**Subject: Sudbury-Hudson Transmission Reliability and Massachusetts Central Rail Trail Project (SWMP #20-07) Issued 01/27/2021
Notification of Minor Change and Request for Administrative Approval**

Attached please find three plan sheets showing the proposed minor change that upon administrative approval would replace the corresponding sheets in the plan set previously approved by the Board.

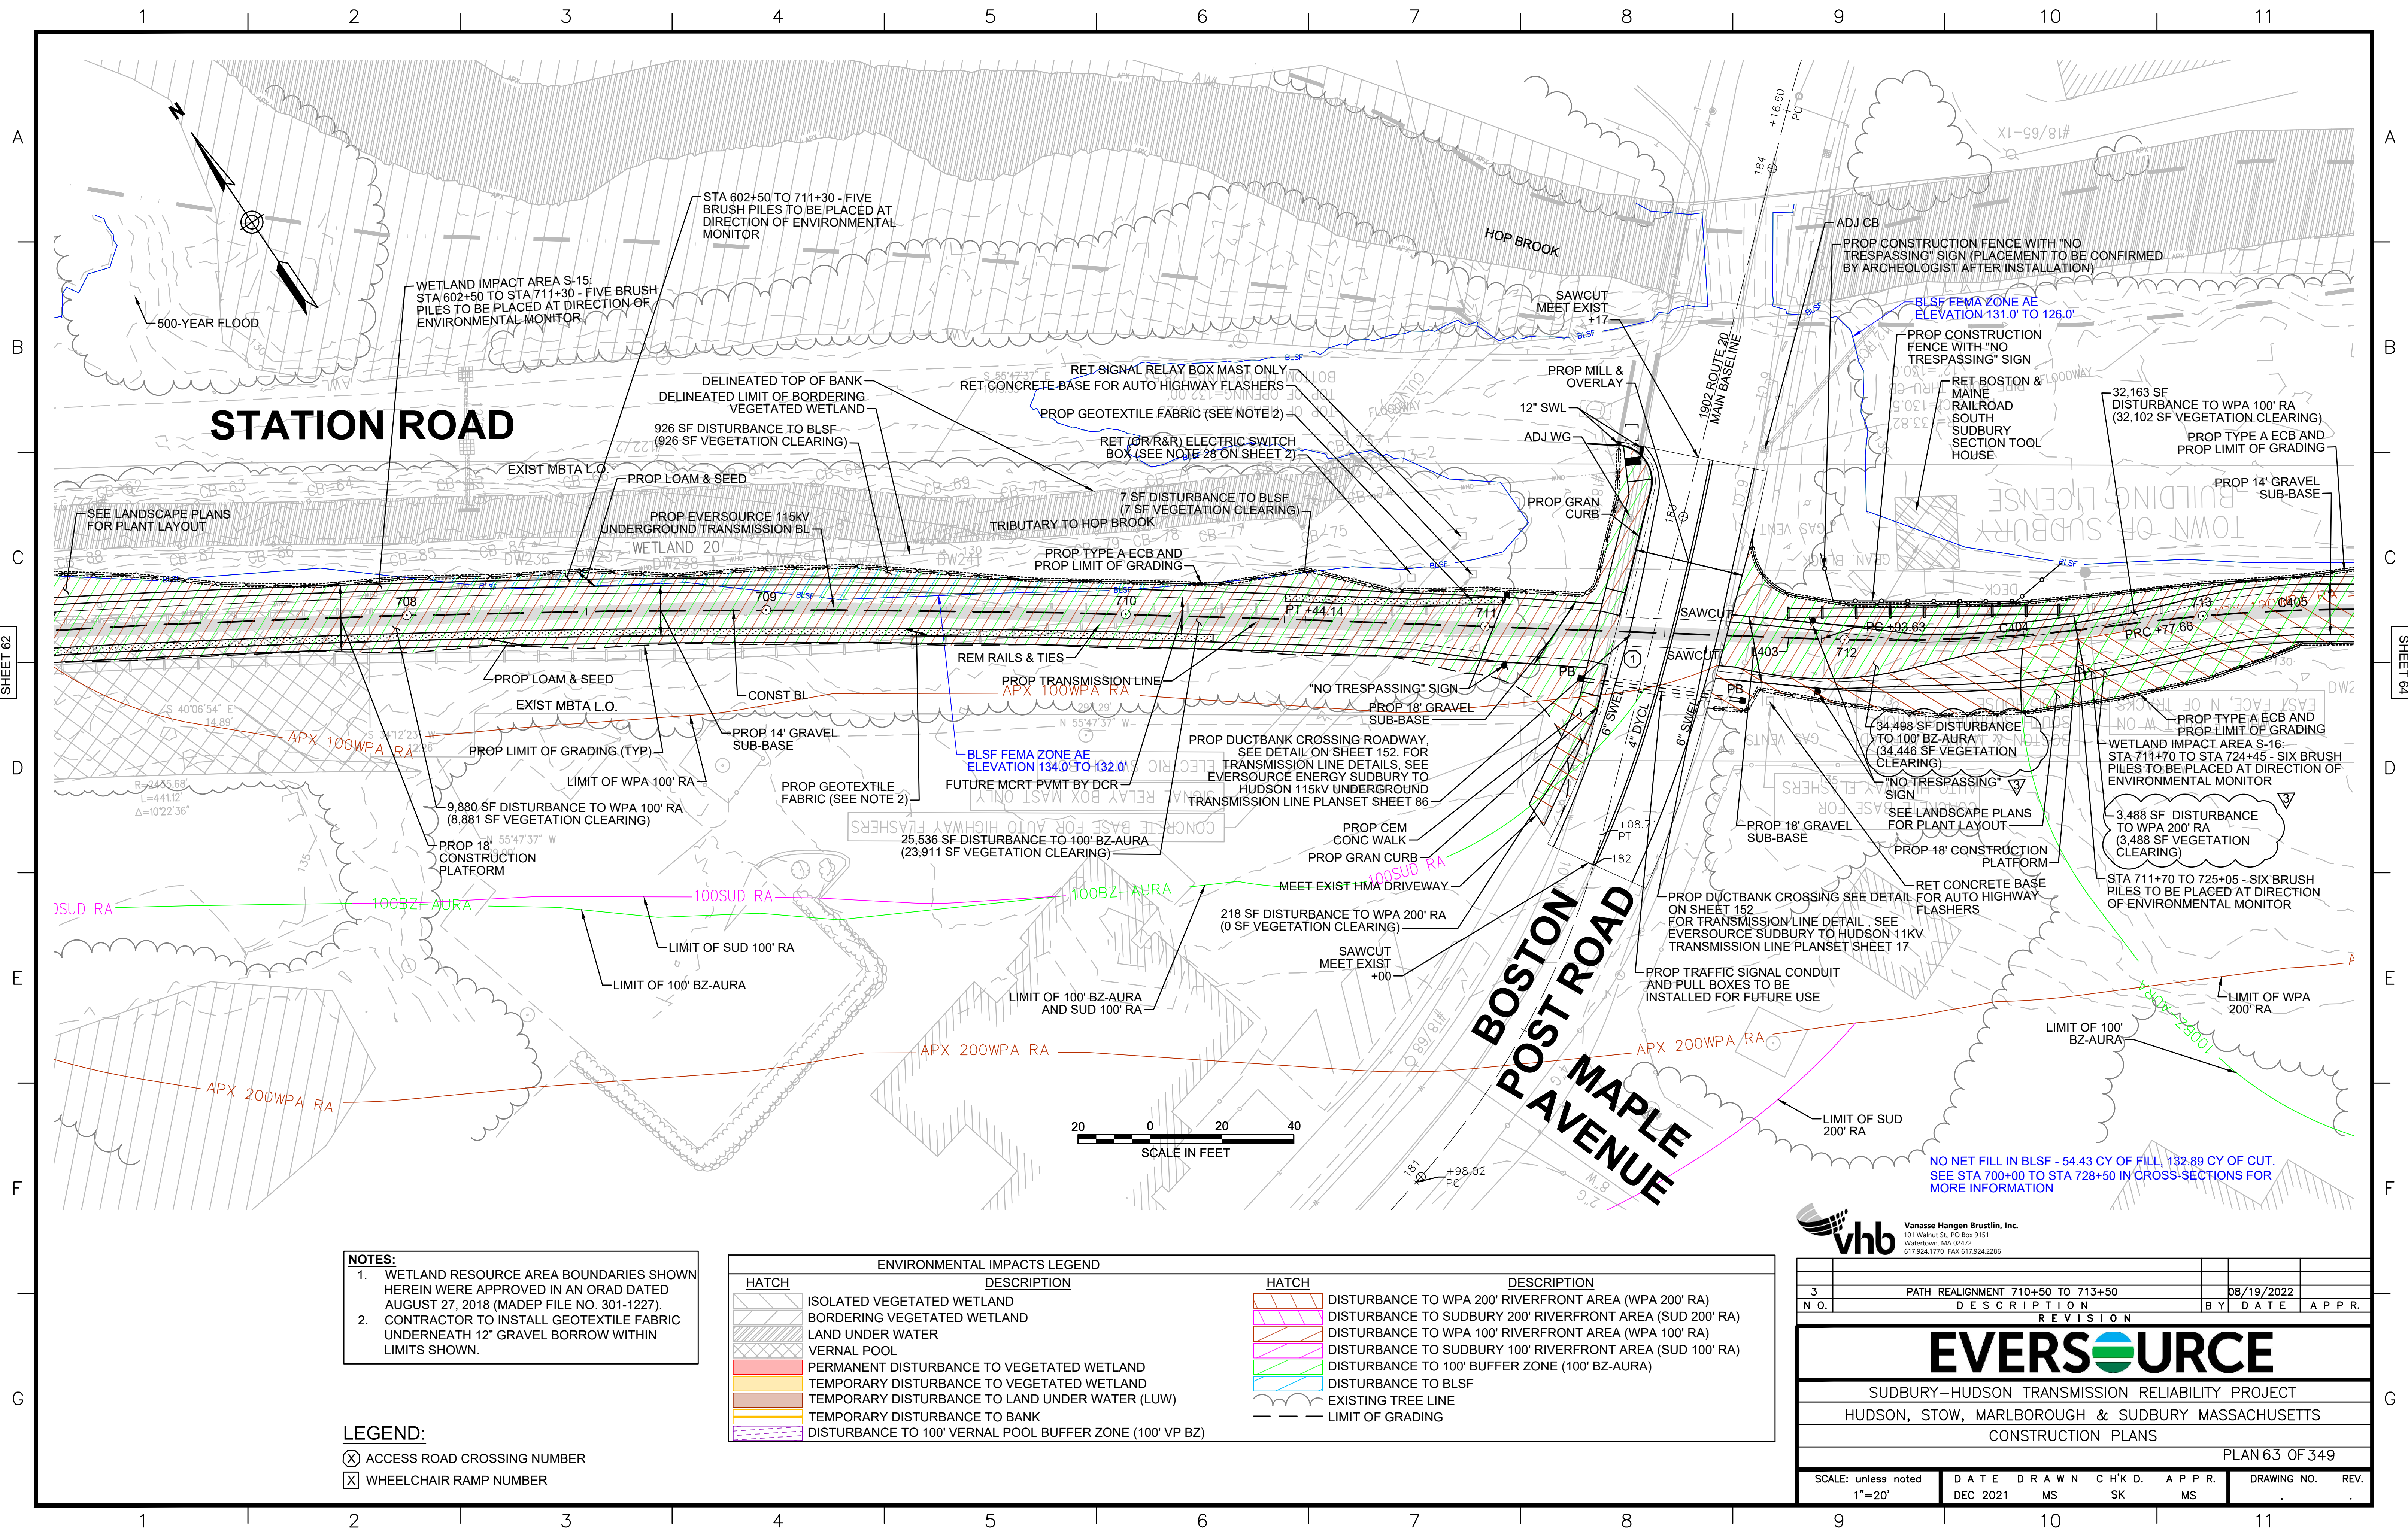
The 160-foot section of realigned bike path does not result in an increase to the approved impervious surfaces from the Project and because it occurs within only 160 feet of the path, the change amounts to a *de minimis* change in stormwater flows. With the minor realignment of 160 feet of the rail trail, stormwater from this section will be directed southward between stations 712+00 and 713+50. This takes advantage of an existing low

area south of the rail bed, and ultimately results in a longer path of travel for stormwater, providing increased opportunity for infiltration and recharge before reaching the culvert at station 713+63.

3	PATH REALIGNMENT 710+50 TO 713+50	08/19/2022		
N.O.	DESCRIPTION	BY	DATE	APP.R.
REVISION				
EVERSOURCE				
SUDBURY-HUDSON TRANSMISSION RELIABILITY PROJECT				
HUDSON, STOW, MARLBOROUGH & SUDBURY MASSACHUSETTS				
CONSTRUCTION PLANS				
PLAN 63 OF 349				
SCALE: unless noted 1"=20'	DATE DEC 2021	DRAWN MS	CHK'D. SK	APP.R. MS
DRAWING NO.		REV.

SUDBURY-HUDSON TRANSMISSION RELIABILITY PROJECT
HUDSON, STOW, MARLBOROUGH & SUDBURY MASSACHUSETTS
CONSTRUCTION PLANS
PLAN 64 OF 349

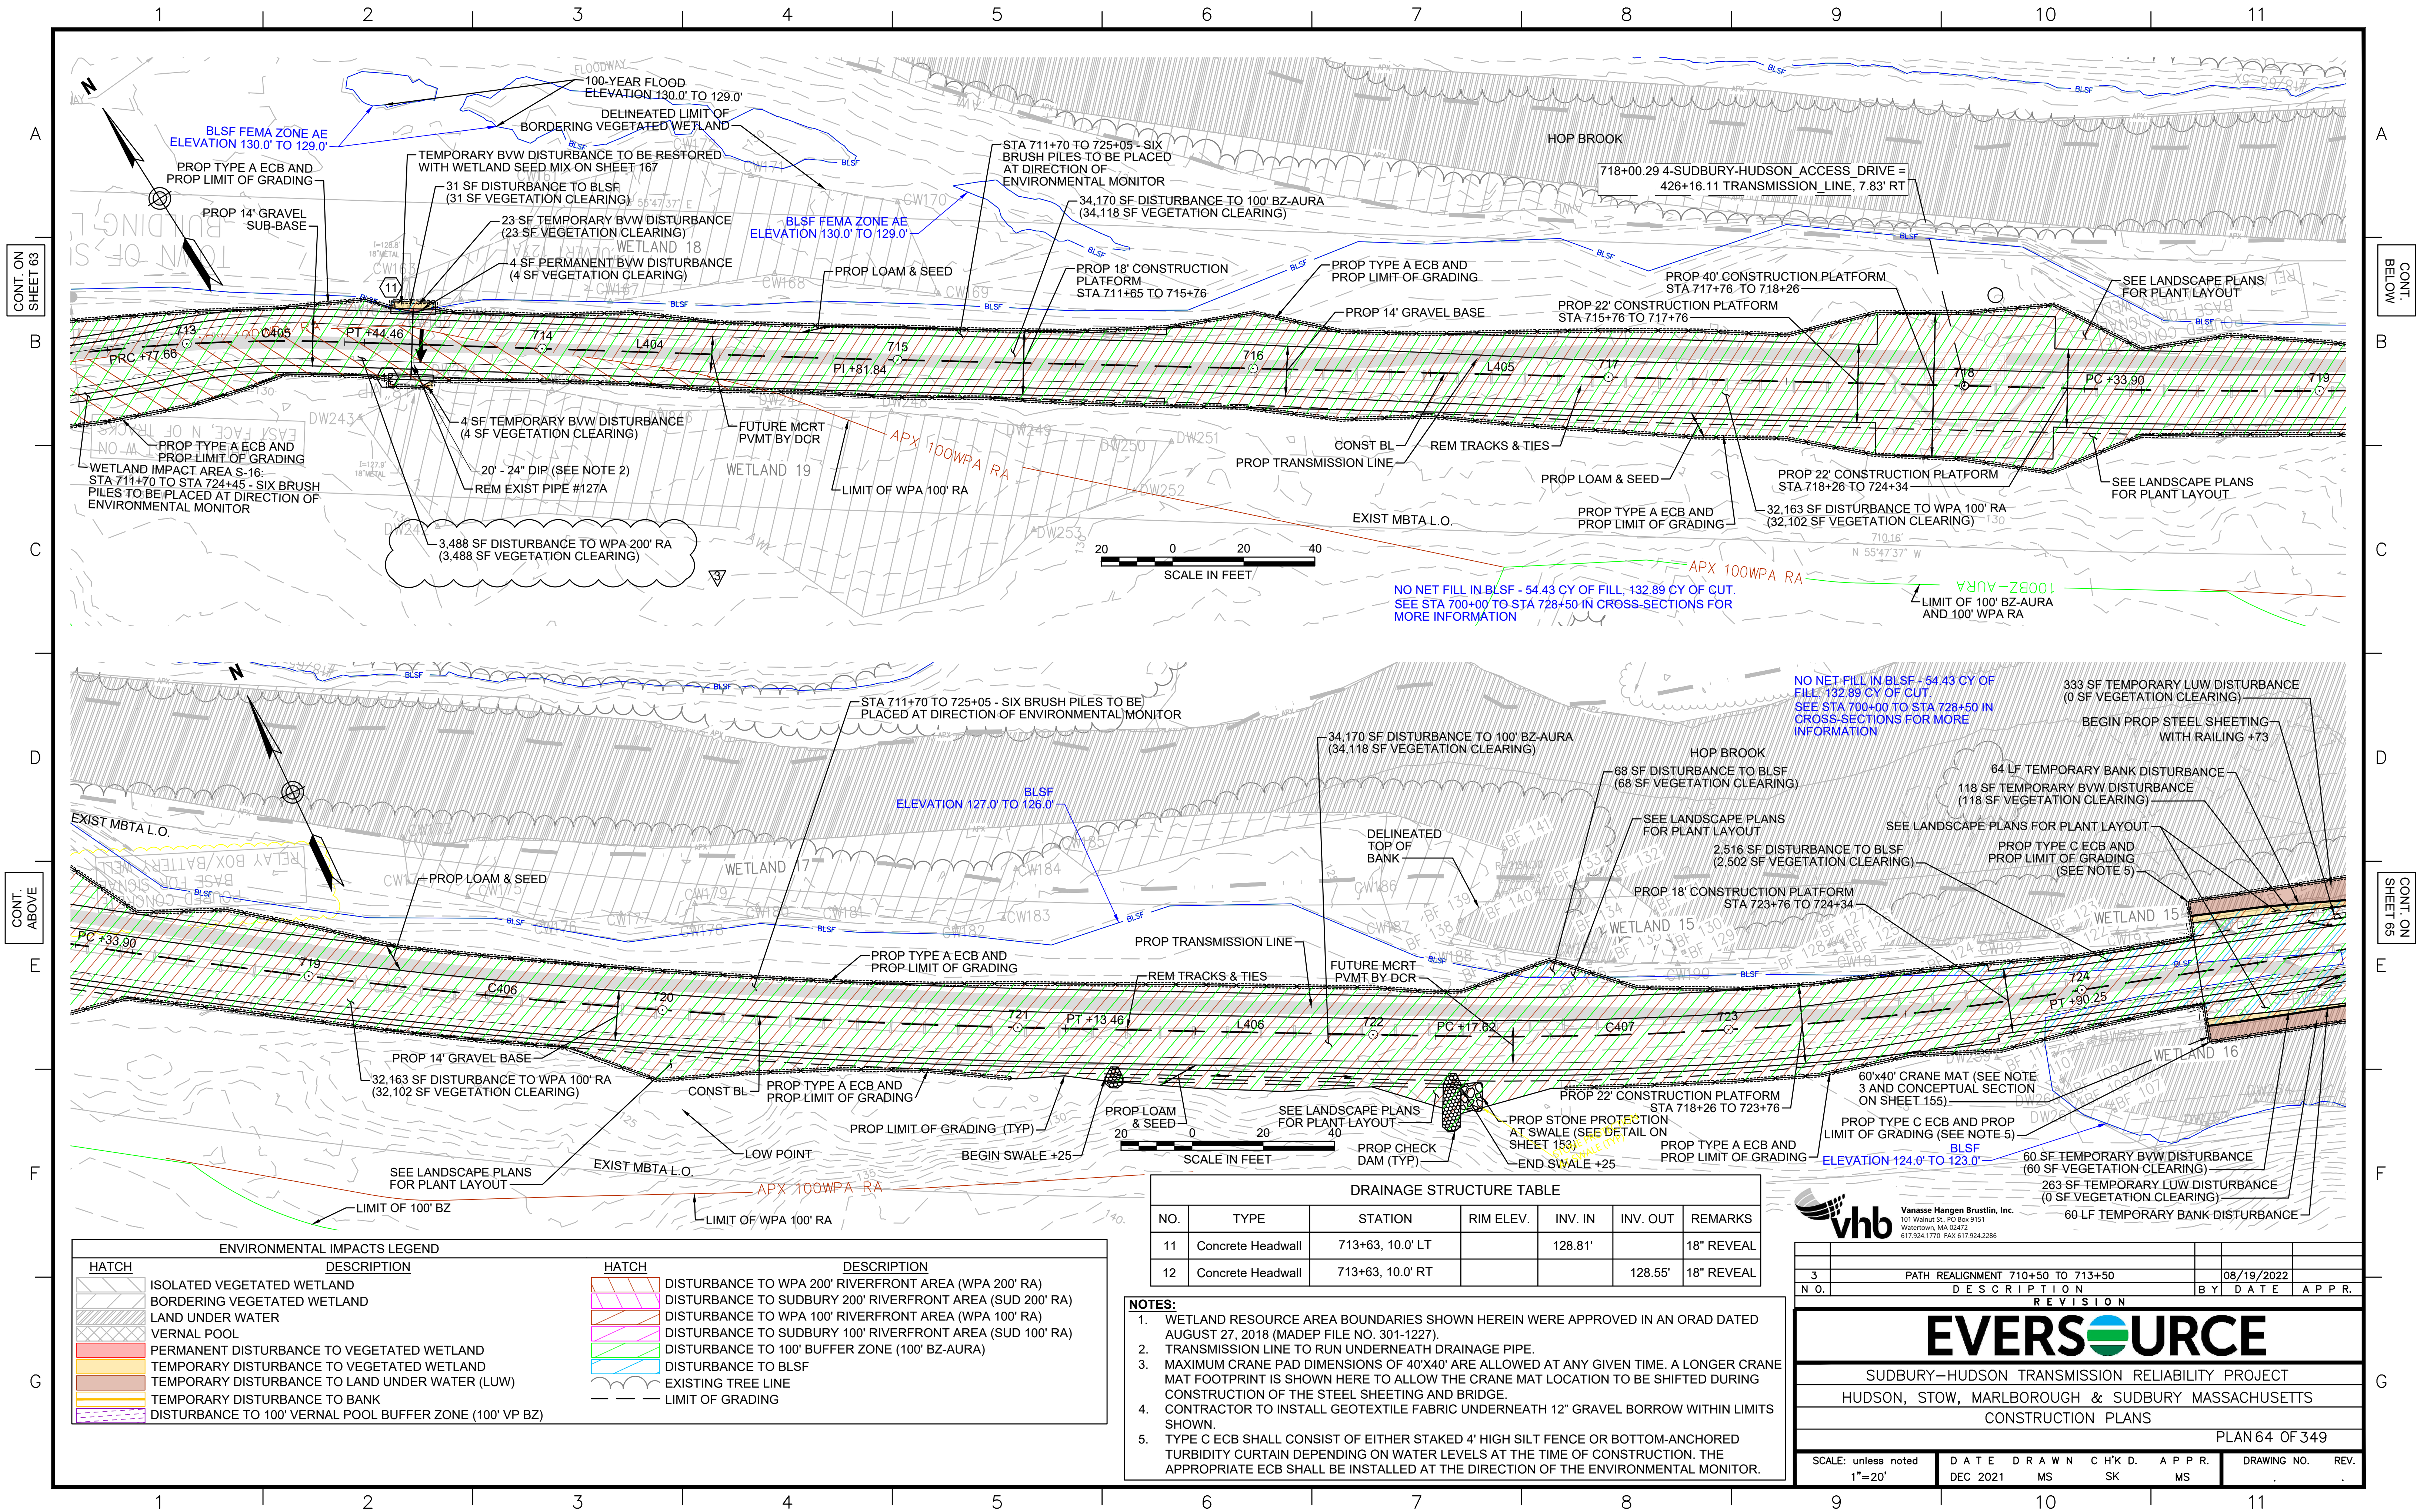
3	PATH REALIGNMENT 710+50 TO 713+50	08/19/2022		
NO.	DESCRIPTION	BY	DATE	APPR.
REVISION
